Dining Room//Existing//Plan_1:20

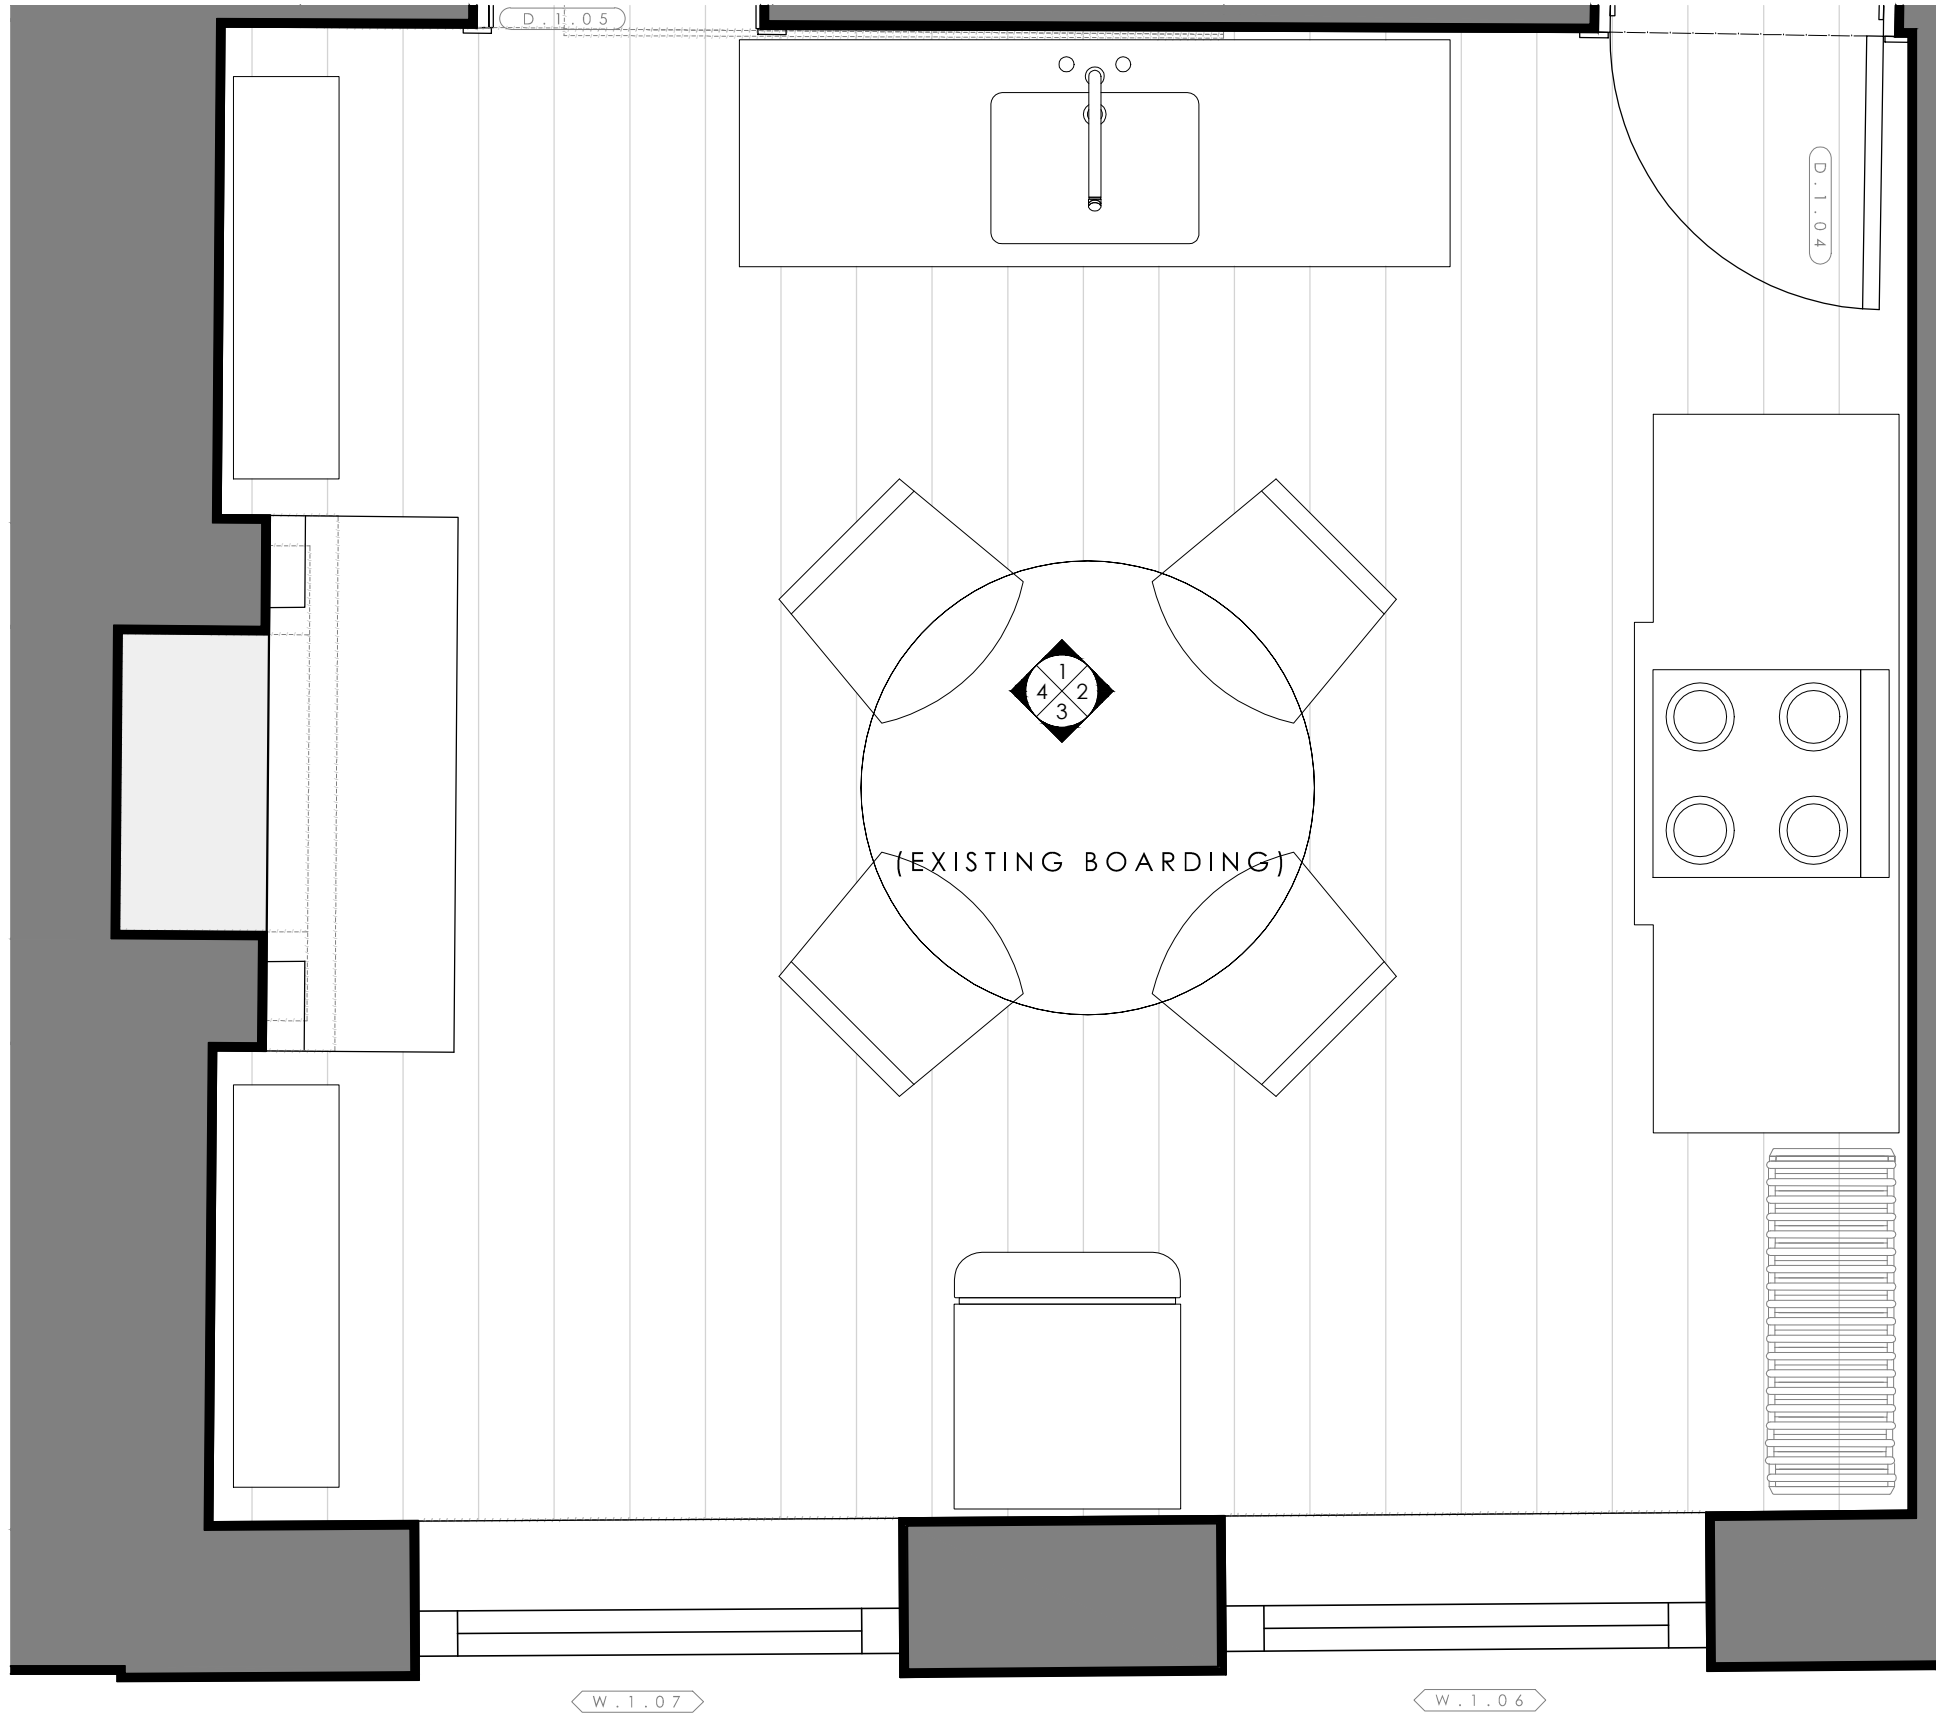
Rev	Date	Notes
A	23.06.15	Layout revised, door location revised and radiator added.

Kitchen//Existing//Plan_1:20

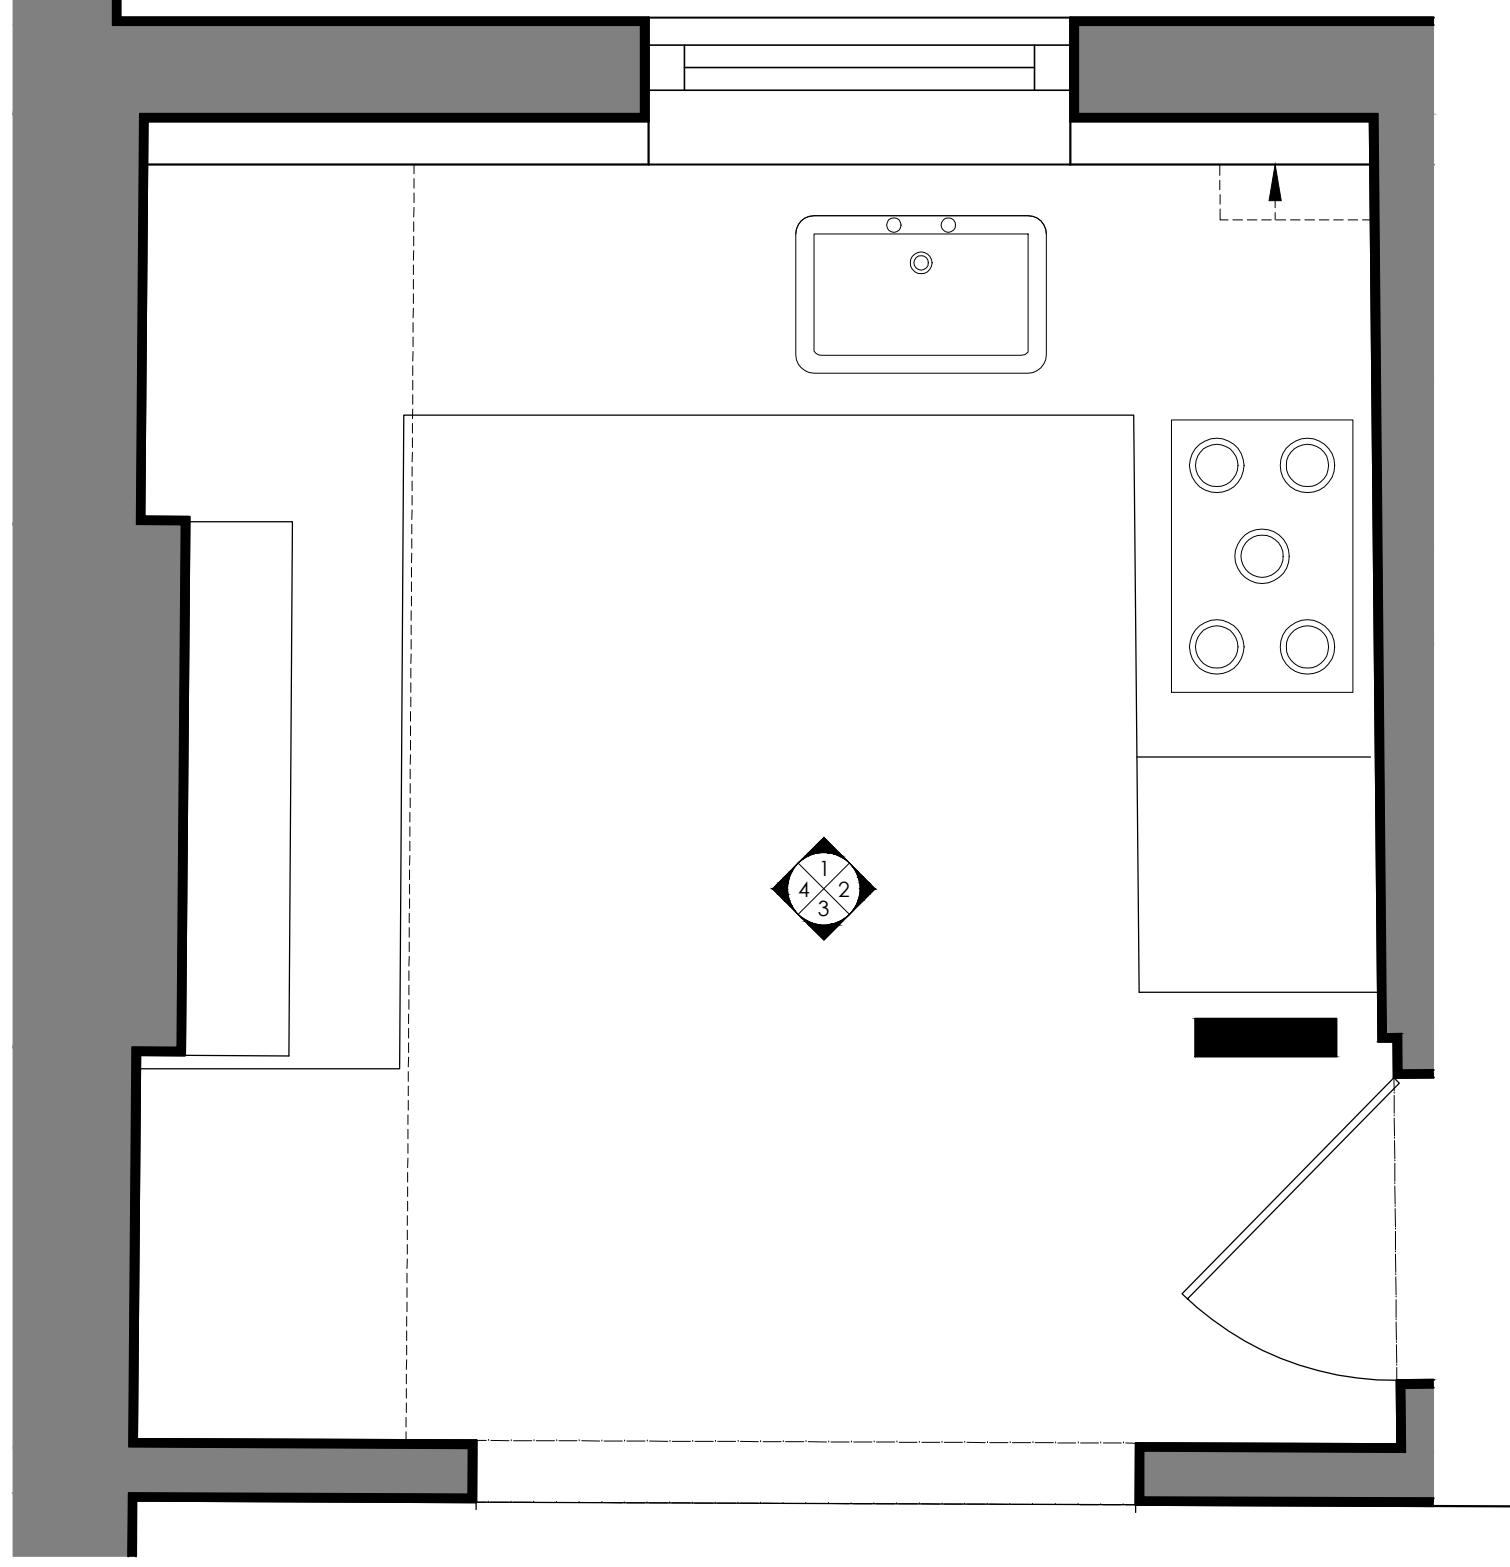
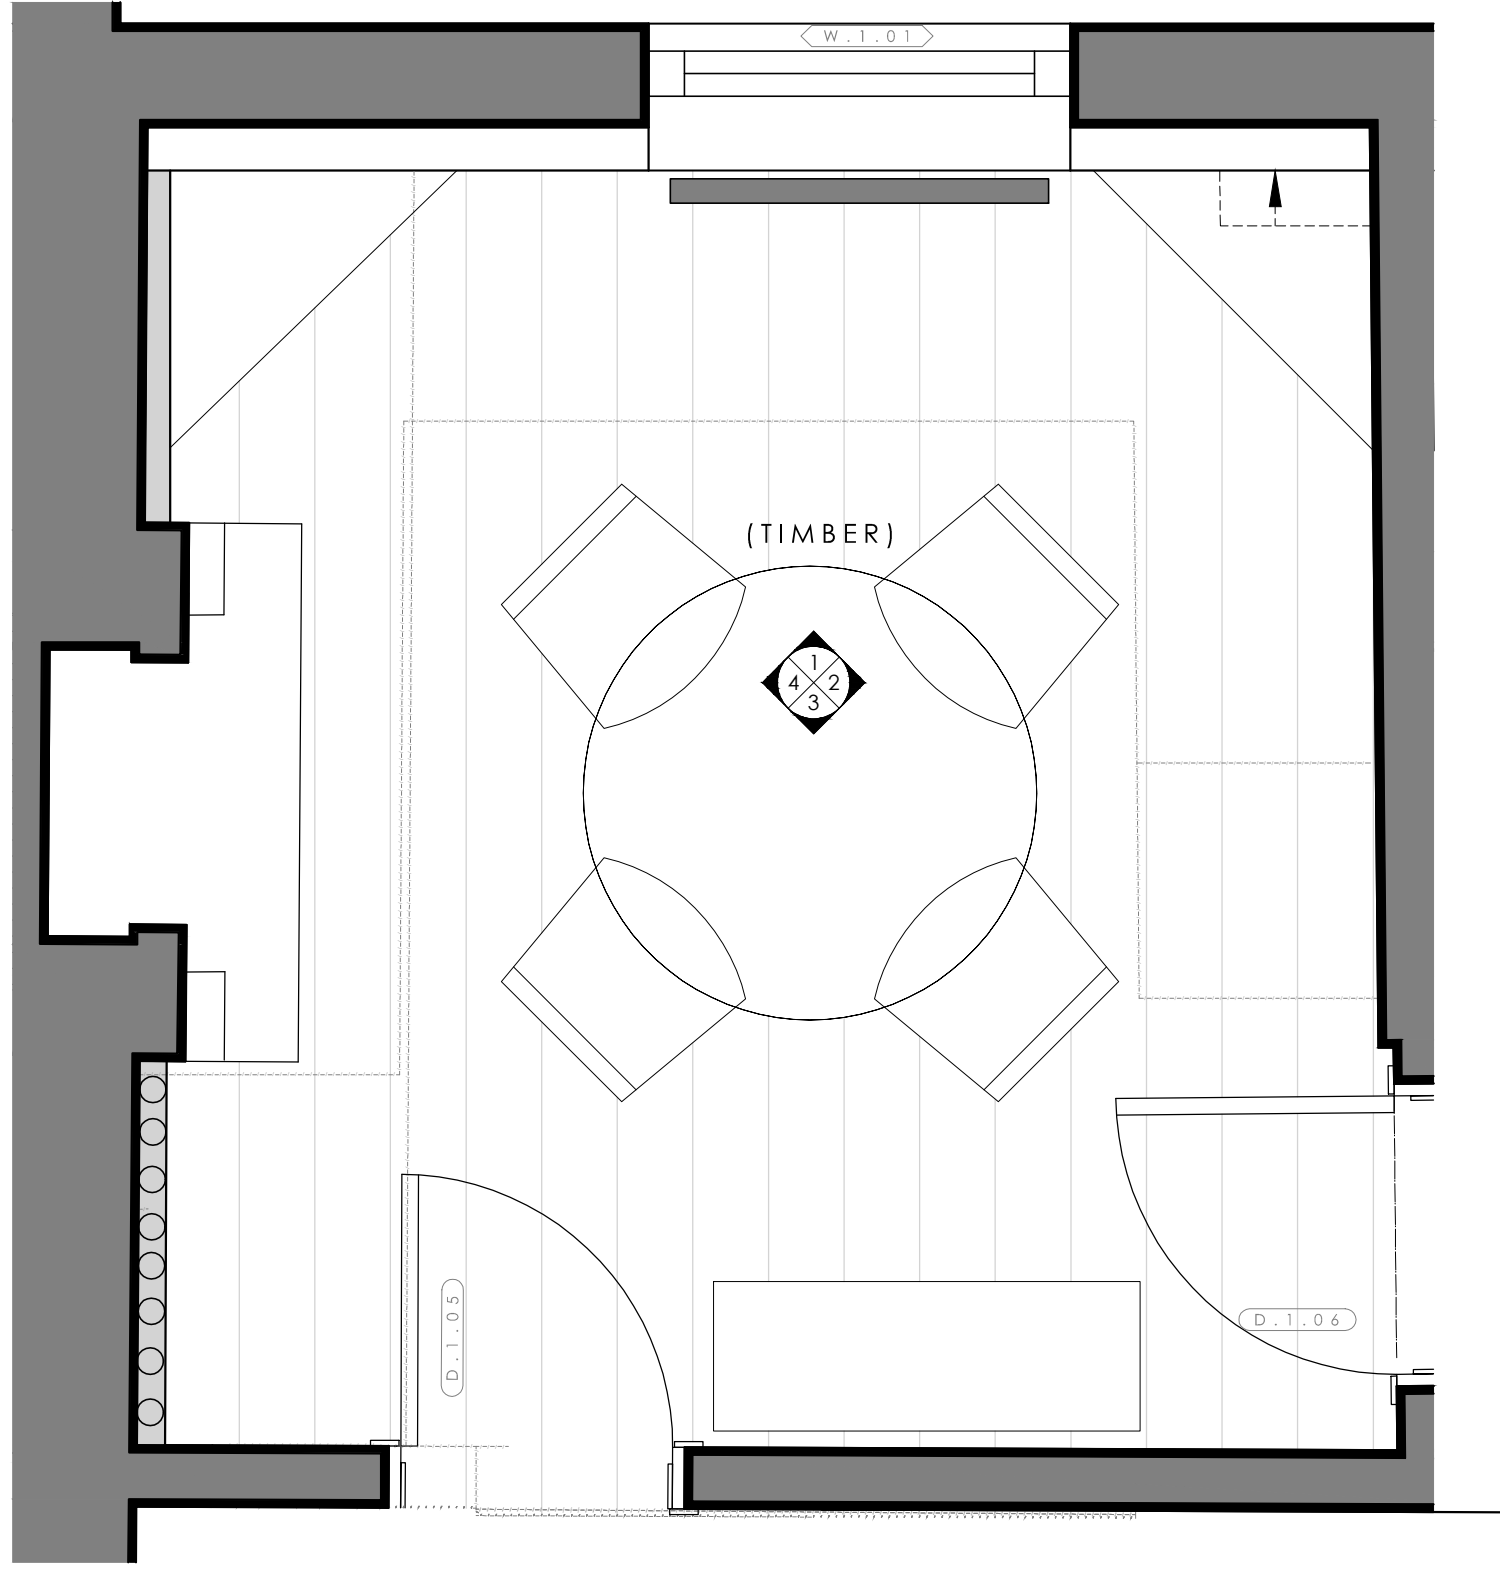
Rev	Date	Notes
A	14.05.15	Service duct stepped back following comments from council.
B	23.06.15	Door location revised

Kitchen//Existing//Elevation 2_1:20

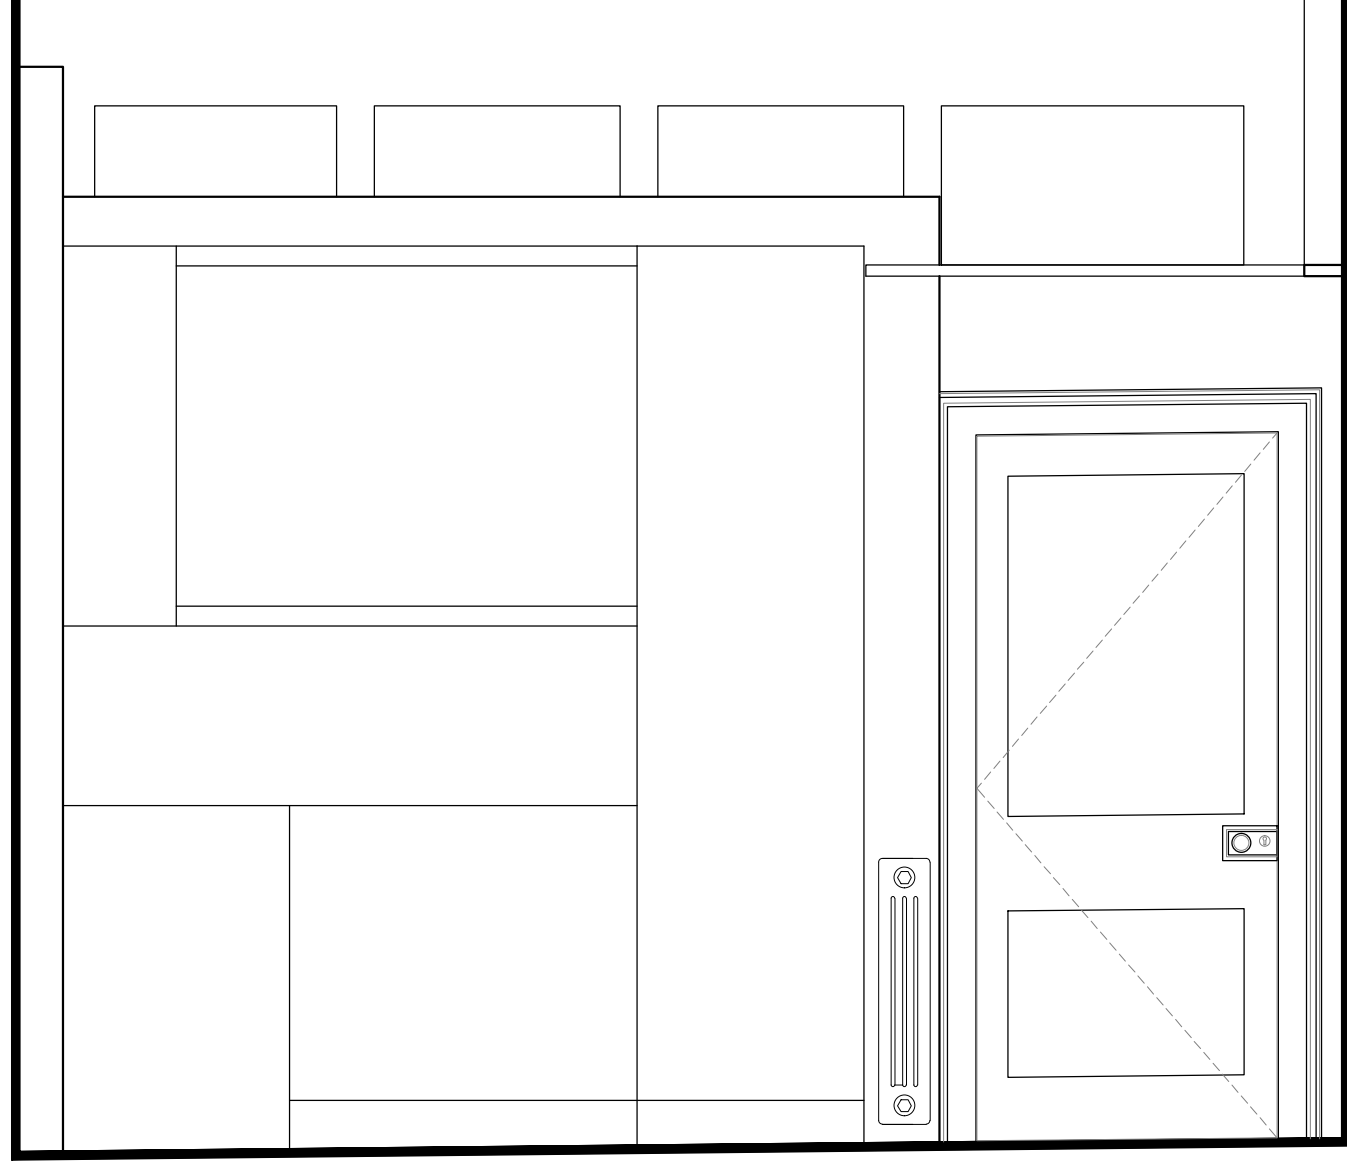
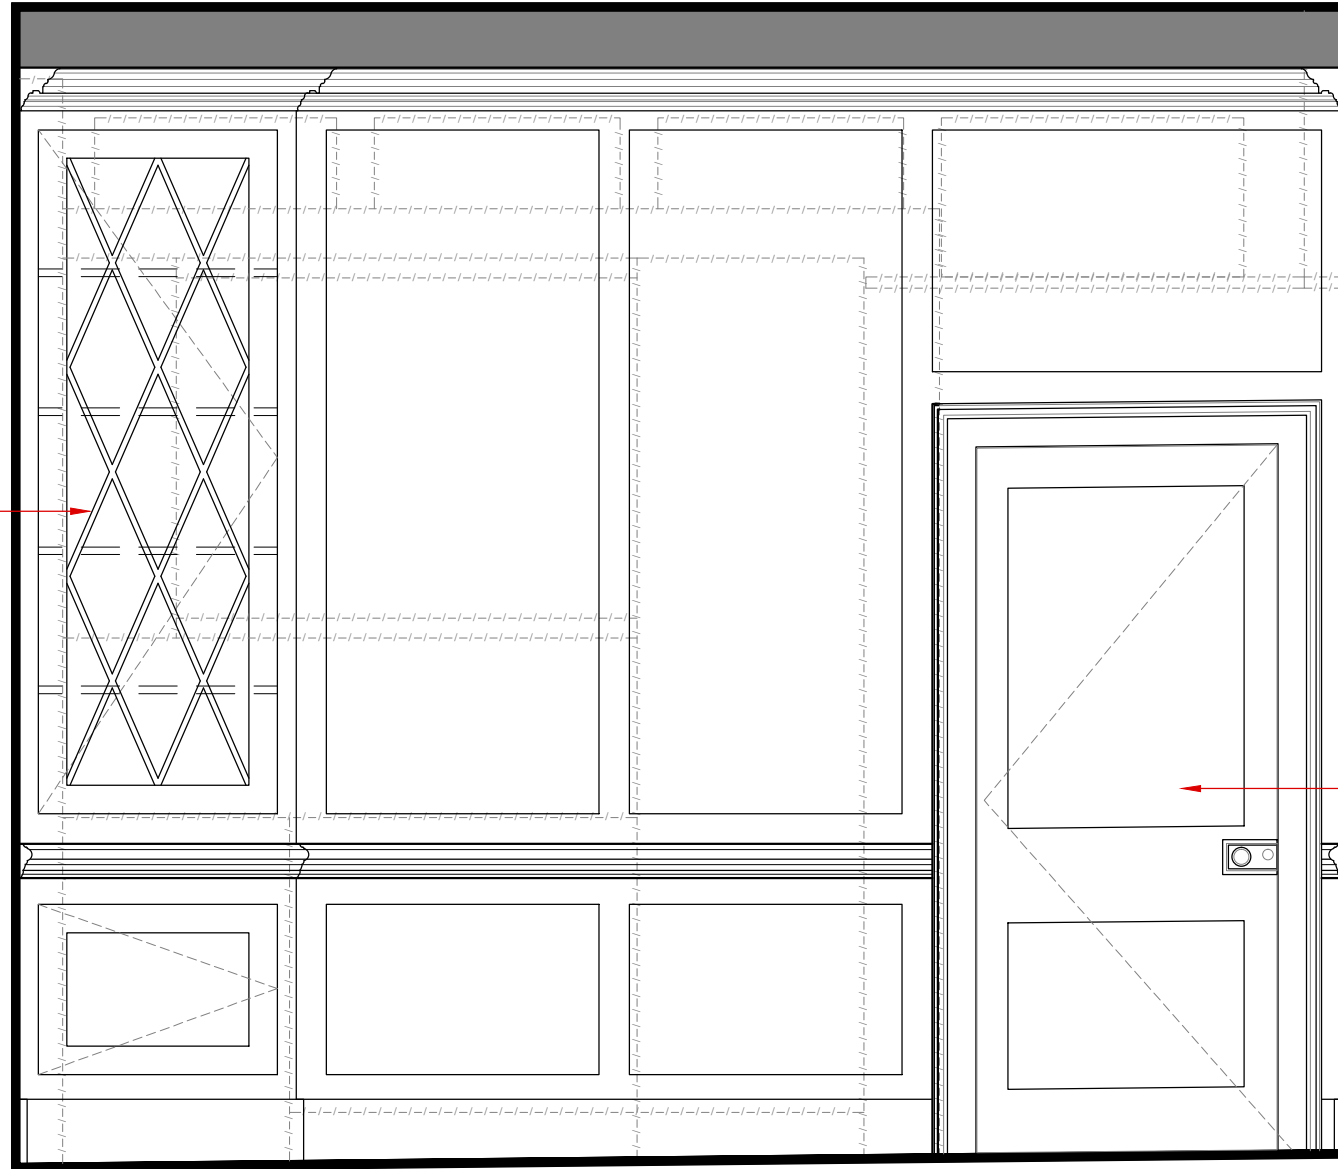
Rev	Date	Notes
A	14.05.15	Door swing retained following comment from council.

Existing original door
retained.
